Ref: EMA/CHMP/CVMP/QWP/BWP/850374/2015

Guideline on the sterilization of the medicinal product, active substance, excipient, and primary container

Parenteral Drug Association (PDA)

Decision tree for sterilisation choices for aqueous products

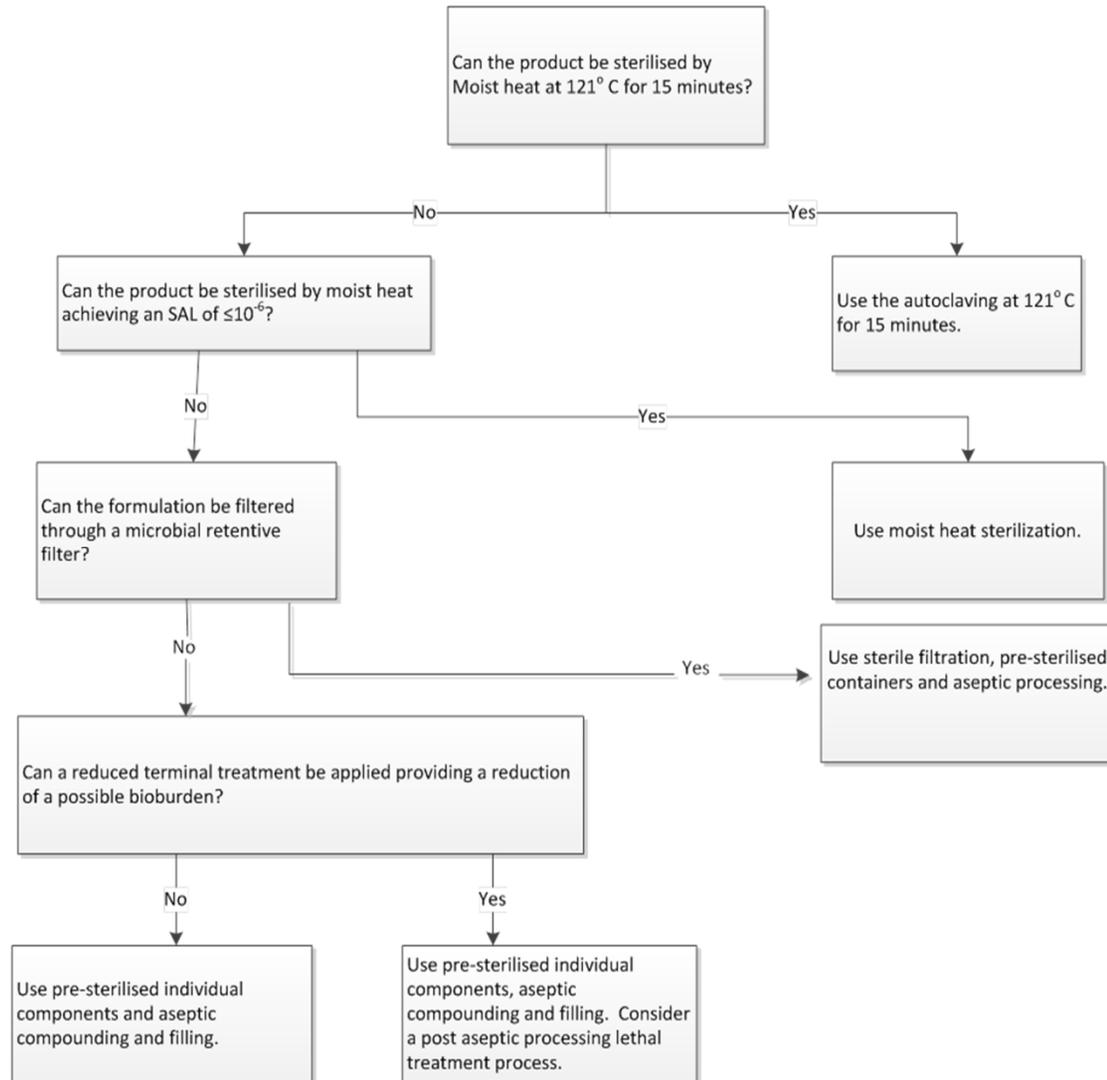
388 Decision Tree; aqueous products		Comment: PDA recommends the diagram be modified as indicated below (see attached Decision Tree) based on the rationale presented for Lines 380-383 above. Additionally, the use of heat treatment should be broadened to include treatment technologies capable of microbiological inactivation besides heat.	Y
